RCA-78-22-006-1: Increase Clearance between Frame Harness and Steering Column

Document Type	Customer Satisfaction Campaign Bulletin
Date	April 12, 2022
Affected Region(s)	USA
Affected Model(s)	R1T
Model Year(s)	2022
Approximate Build Dates Refer to the FSA Dashboard to determine if this document applies to a specific vehicle.	August 2021 - October 2021
Vehicle System	78 - Low Voltage Electrical
Minimum Service Location	Mobile

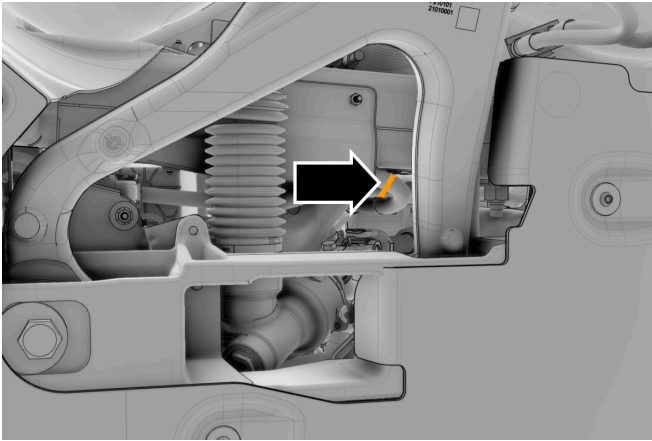
2. Install the cable tie to secure the frame harness to the power steering harness. Tighten the cable tie enough so that the frame harness can not contact the steering column intermediate shaft.
